MJ 11-A

FIELD SERVICE TECHNICAL MANUAL				Option or Designator
	12 Bit <input type="checkbox"/>	16 Bit <input checked="" type="checkbox"/>	18 Bit <input type="checkbox"/>	36 Bit <input type="checkbox"/>	MJ11 MEMORY

MJ11
MEMORY TIMING AND CONTROL
FCO Cross Reference

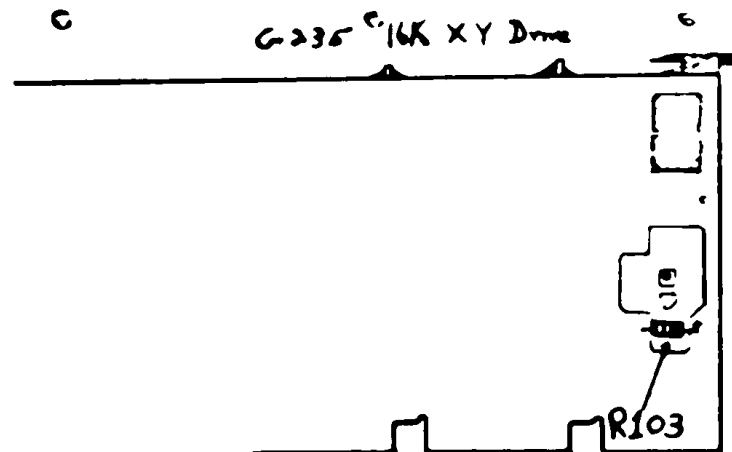
Many reports have been received from the field concerning memories failing high current margins and module set incompatibility (i.e. unable to swap modules). Investigation has shown that the inhibit margins are not properly centered, which could cause marginal operation of the memory under conditions of high drive currents. An ECO (G235-0009) was generated to correct this problem.

Therefore, if a memory exhibits these symptoms, do a visual inspection of the G235 for the ECO. A quick check for the ECO is:

1. Place G235 component side up and fingers toward you.
2. Look at right hand side of module in large etch area (see drawing).
3. If resistor R103 (750 1W) which is across bottom of large etch is not in, ECO has not been installed.

This ECO should be installed before attempting massive module swap or option swap.

ECO # MM11E-00015

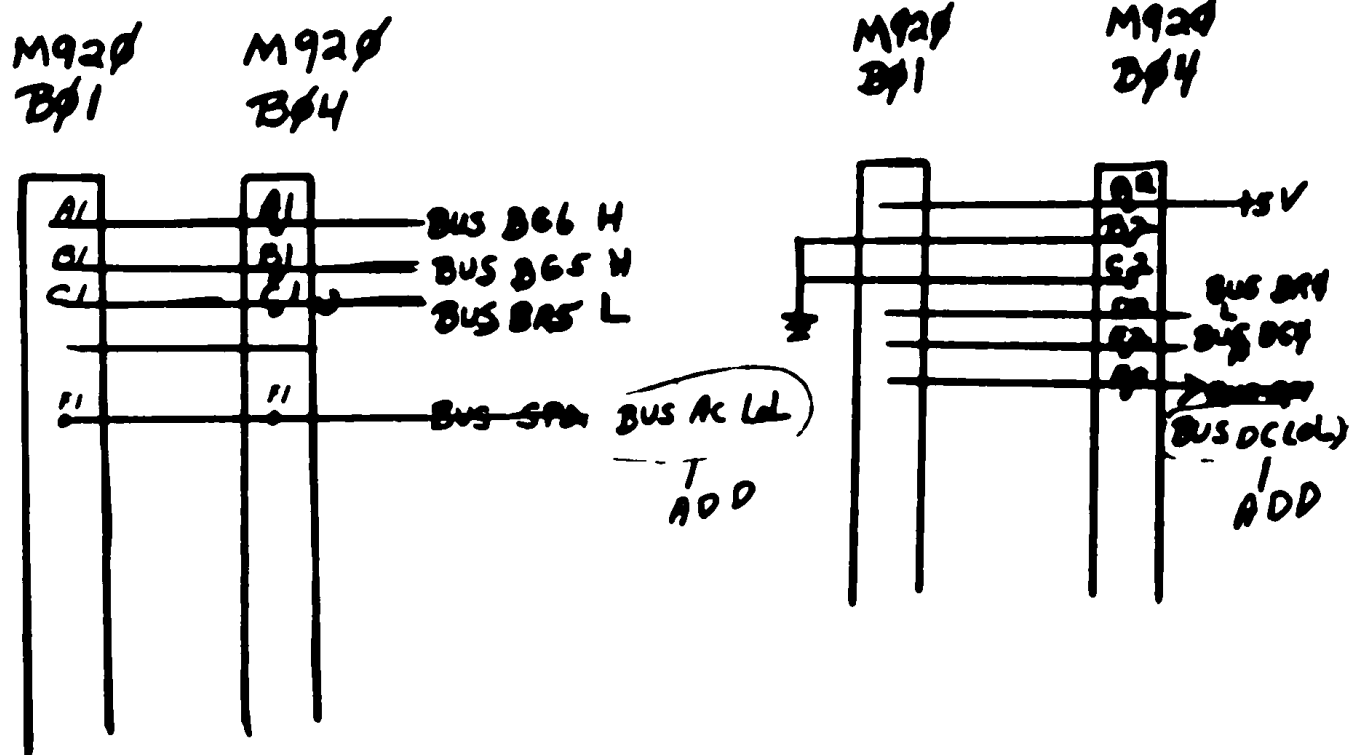
- INSTALL WIRES.
- CORRECT PRINTS.
- NOTE: IF INSTALLATION OF THIS UNIT CREATES A MULTIPLE BOX SYSTEM, THIS ECO AND ECO NUMBER 5408475-00006; ECO NUMBER M930-00001 MUST BE INSTALLED. ONE SET OF CONNECTIONS BETWEEN THE POWER BUS AND UNIBUS ARE REQUIRED FOR EACH BALL WITHIN A SYSTEM.

COLOR	SIGNAL NAME	FROM PIN	TO PIN	COMPONENTS	ADD	DEL
	BUS ACL0L	B04F1	A03R2		X	
	BUS DCL0L	B04F2	A03S2		X

D-TD-MM11E-08
ECO# MM11E-00016

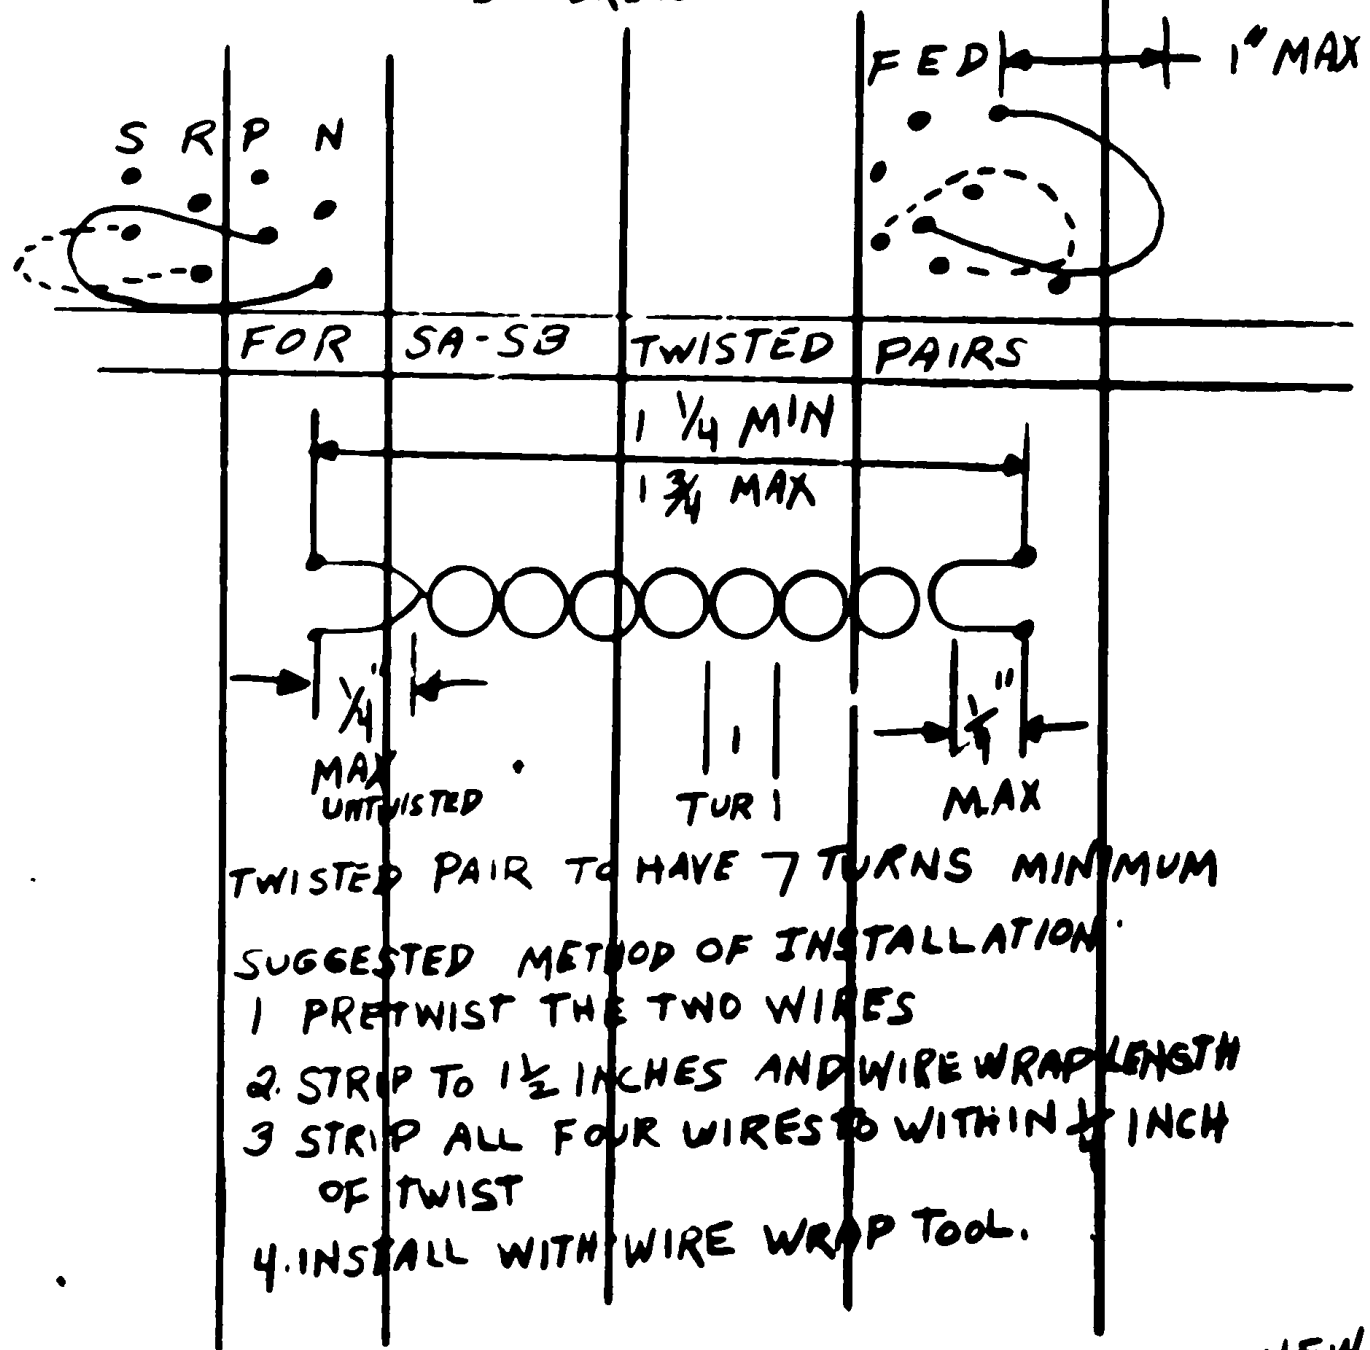
1. TIMING + FLOW DIAGRAM WRONG.
2. NOT ENOUGH INFORMATION GIVEN ON THE DRAWING TO INSURE THE REQUIRED RESULTS WHEN HAND WIRE WRAPPING. TWISTED PAIRS WILL PICK BACK PLANE NOISE UNLESS DONE CORRECTLY.

LENGTH SHOULD BE A MAXIMUM OF 2 1/4 INCHES. CHECK DRAWINGS FOR LENGTH AND FOR HOW LOOPS SHOULD BE DRESSED INTO LOGIC.

1. CORRECT TIMING + FLOW DIAGRAM
2. ADDITIONAL INFORMATION PUT ON THE PRINT.

ENGINEER NO CHANGE ORDER	CORP. MEMORY STACK (X DRIVE)		Dwg No. D-03-MM115-03	REV B
	DATE	BY

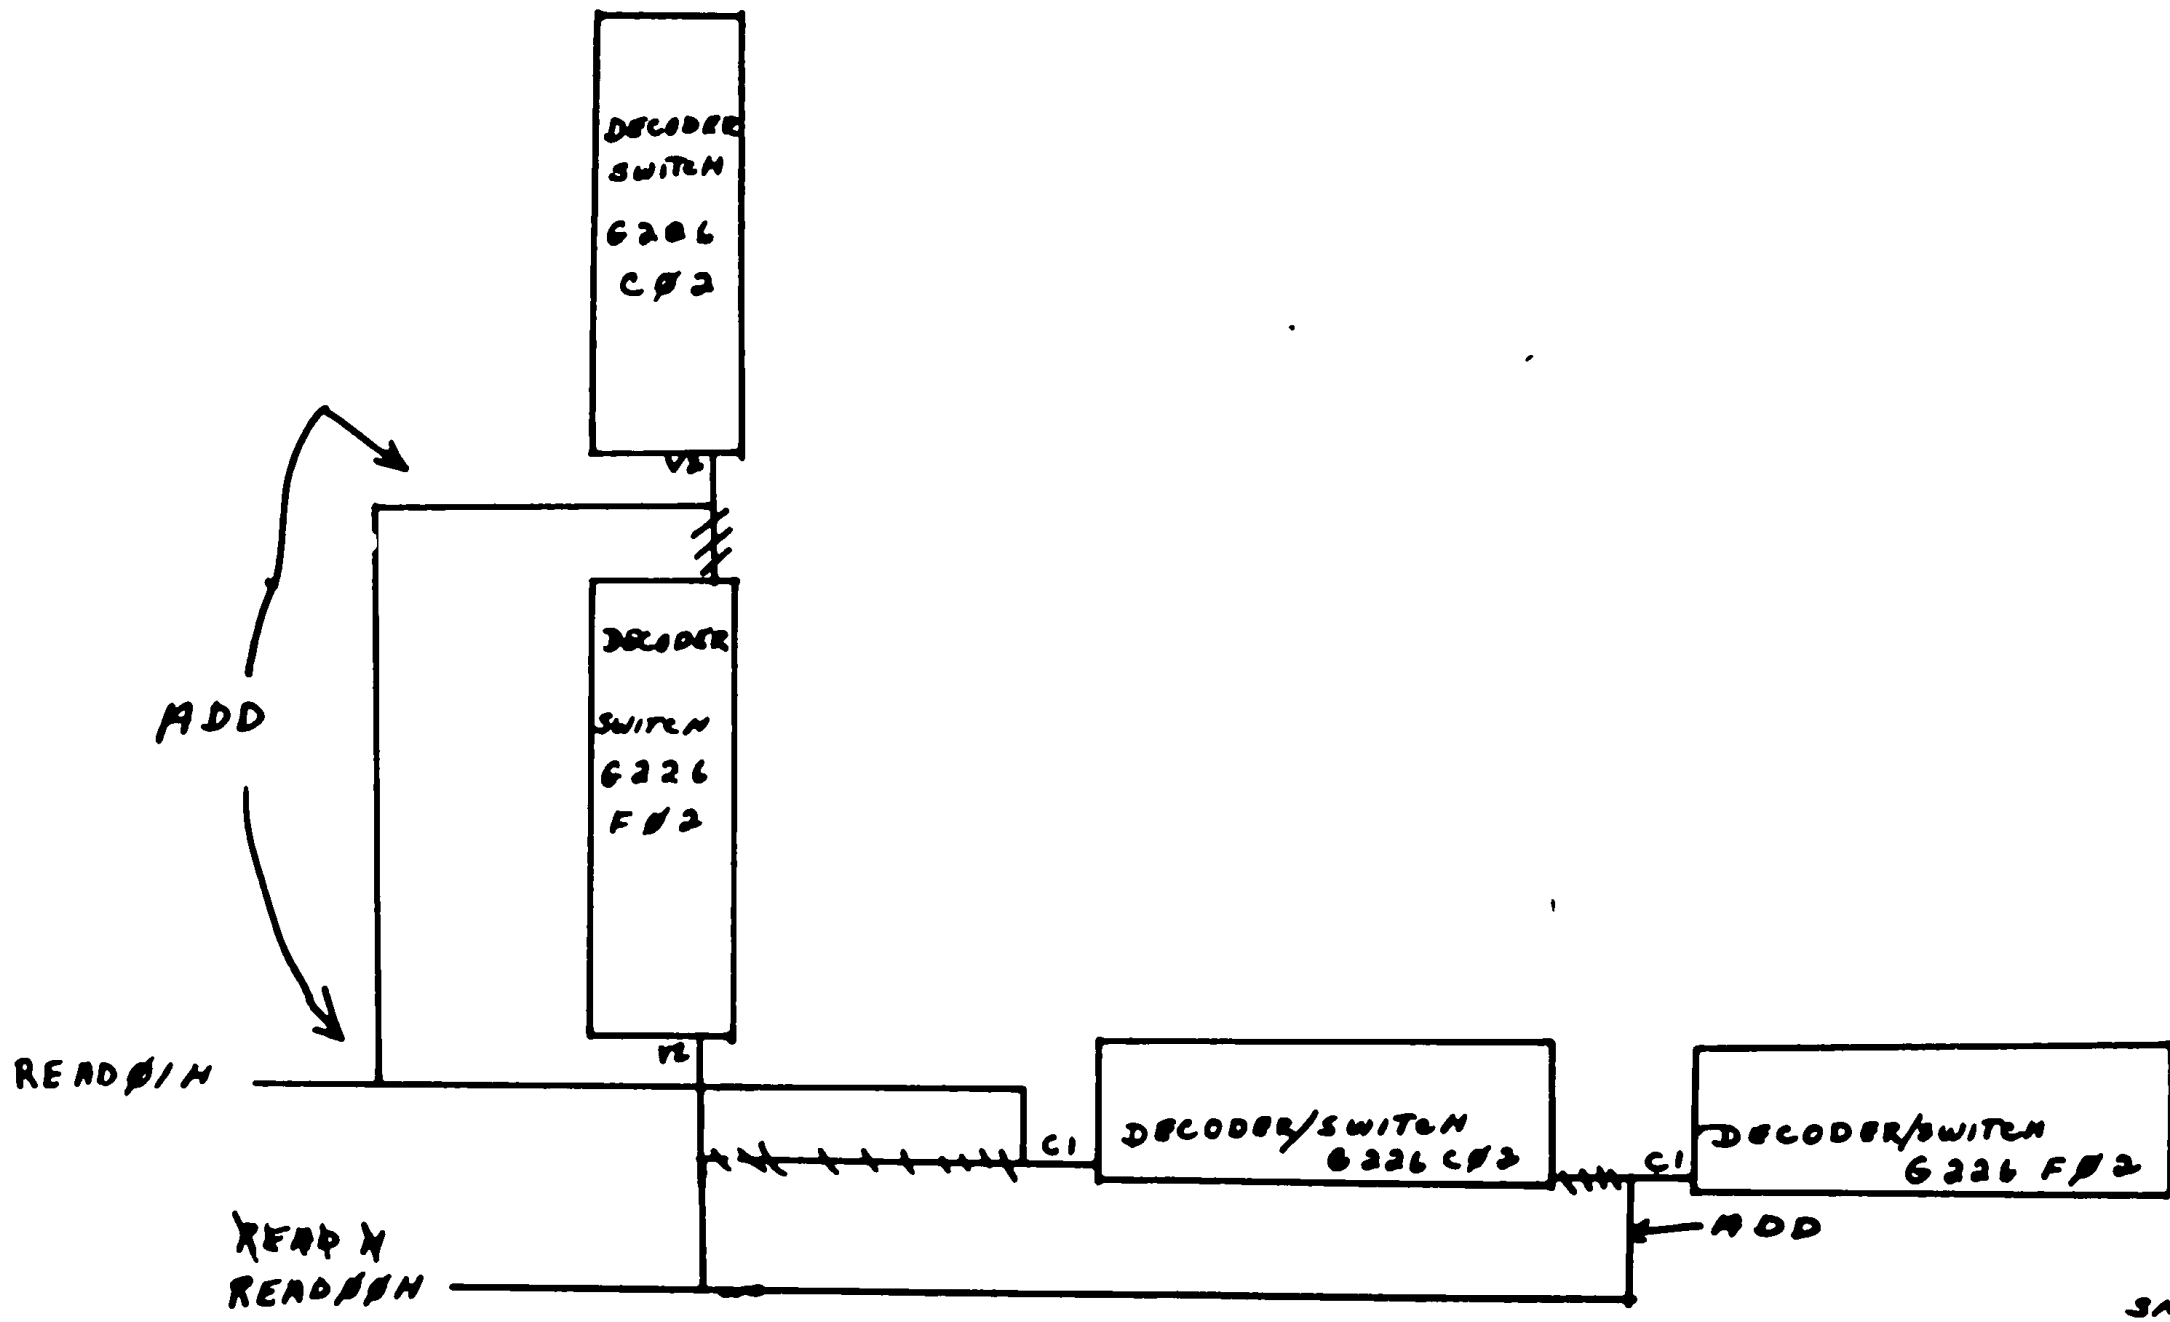
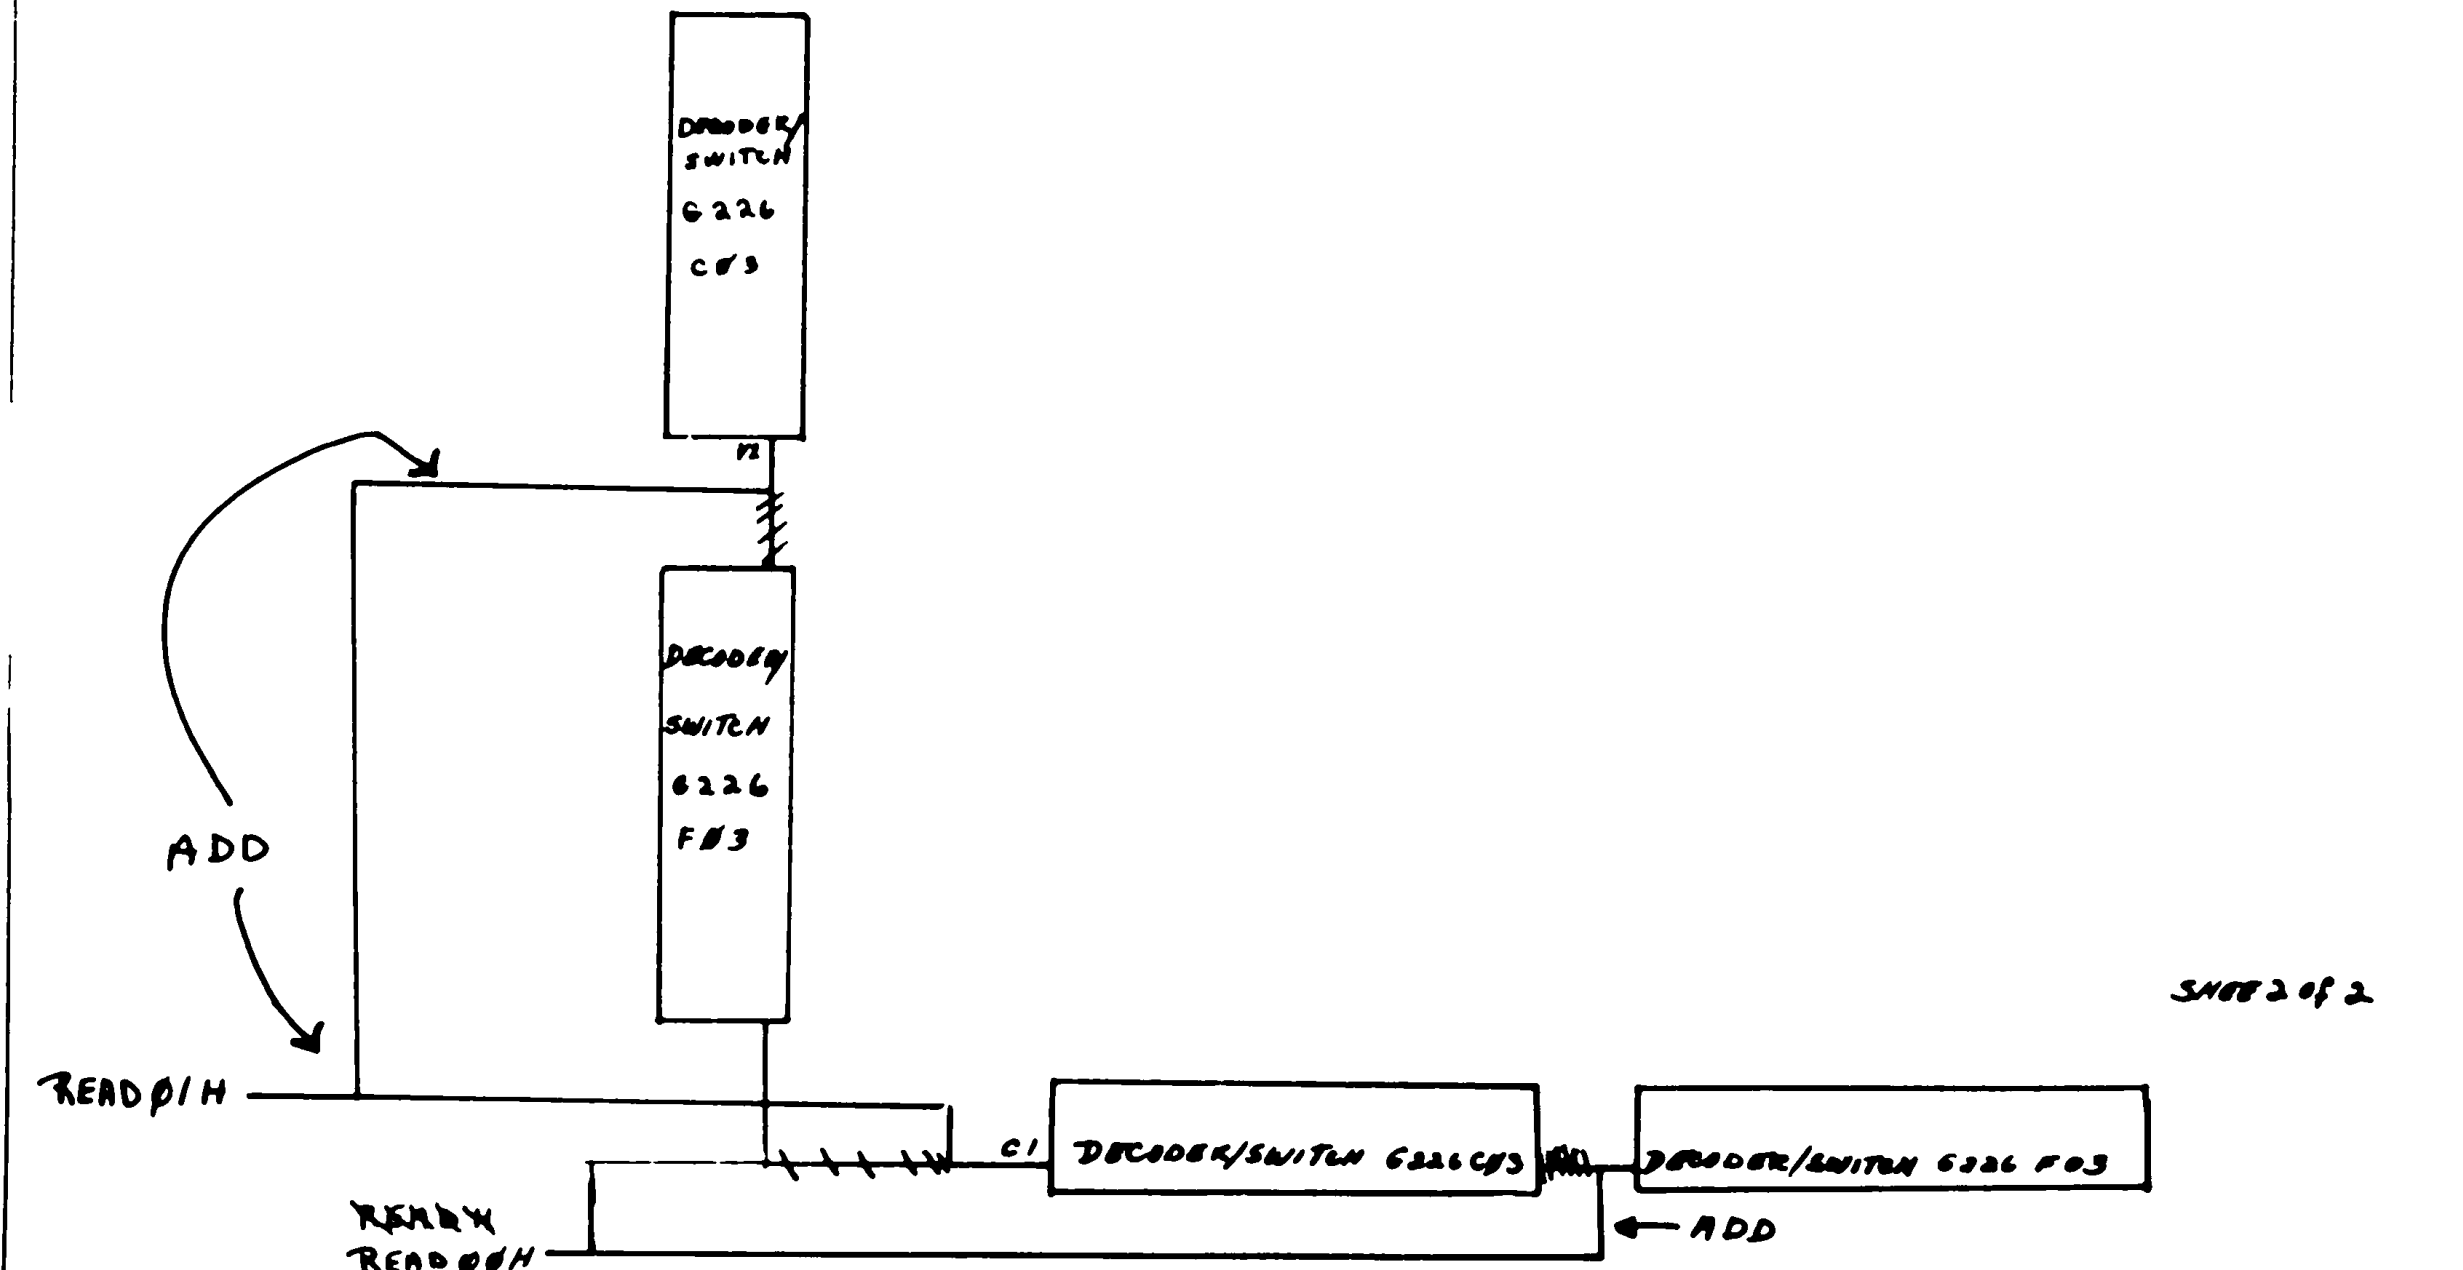
CORE MEMORY STACK (Y DRIVE)	D-05-MM16-03	REV B
	<i>Alvin Smith</i>		
NGI 1116 1/14/64			GRAPHIC DESCRIPTION

ECO MMIF
MMIF REWORK SHEET

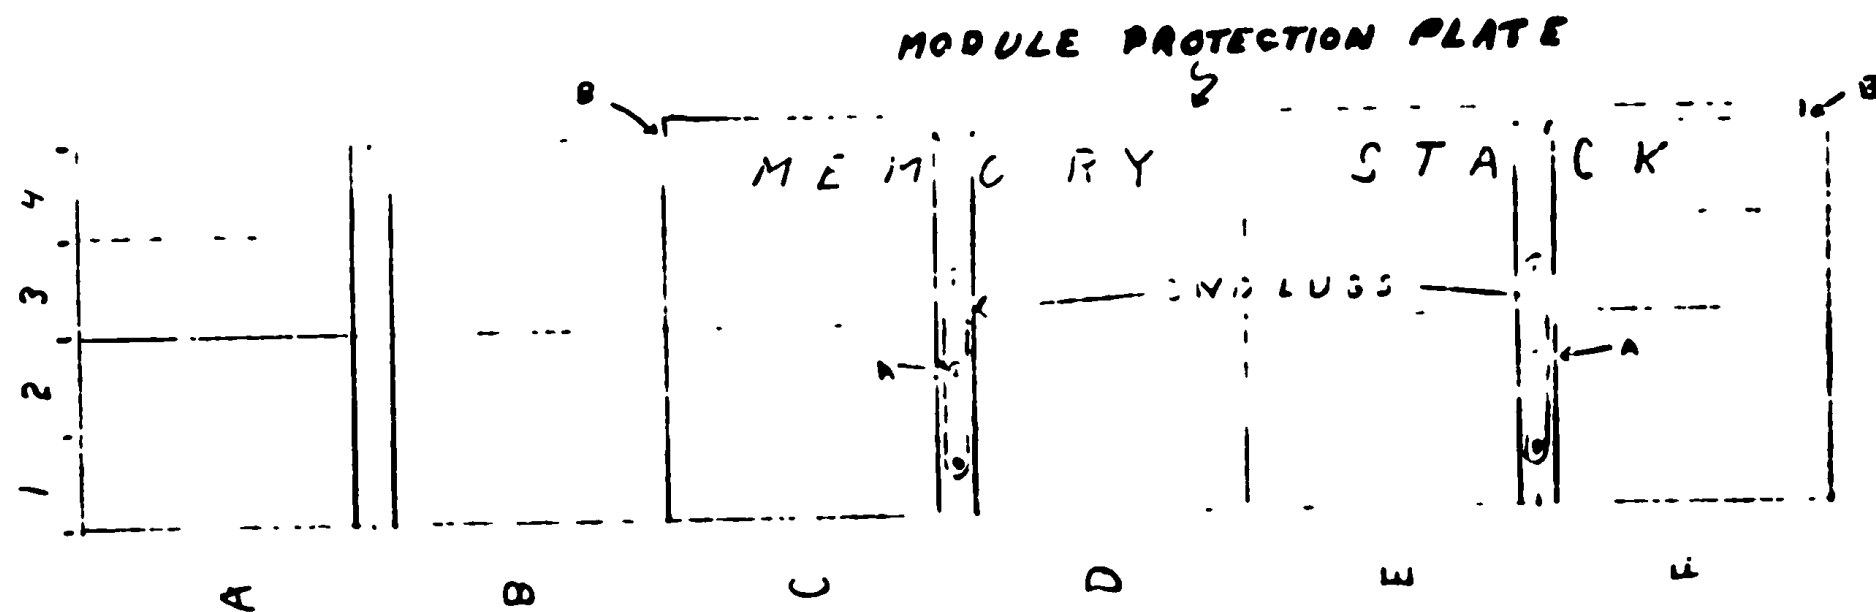
ITEM NO	DOCUMENT/PART NO	OLD REV	NEW REV	DISP CODE	DESCRIPTION OF CHANGE	DOCUMENTATION AFFECTED	FIELD SERVICE AFFECTED	TYPE OF CHANGE
1.	A-PL-MM11-F-0	0	A	06	(Memory Assembly MM11/F) Change per this ECO.	<input type="checkbox"/> MODEL <input type="checkbox"/> DIAGNOSTICS <input type="checkbox"/> TECH MANUAL <input type="checkbox"/> TESTER <input type="checkbox"/> TEST PROG <input type="checkbox"/> TOGLING <input type="checkbox"/> PKG INST <input type="checkbox"/> ENG SPEC <input type="checkbox"/> PUNCH SPEC	<input checked="" type="checkbox"/> YES <input type="checkbox"/> NO <input type="checkbox"/> Customer Charge <input type="checkbox"/> Product Line Change	<input type="checkbox"/> ELECTRICAL <input checked="" type="checkbox"/> MECHANICAL <input type="checkbox"/> MODULE ORDER PR MODEL <input type="checkbox"/> YES <input checked="" type="checkbox"/> NO

2.	7408490	-	-	07	(Module Protection Plate) Add quantity of 1 to drawing index.			
3.	A-ML-MM11-F	0	A	06	Update per item 1.
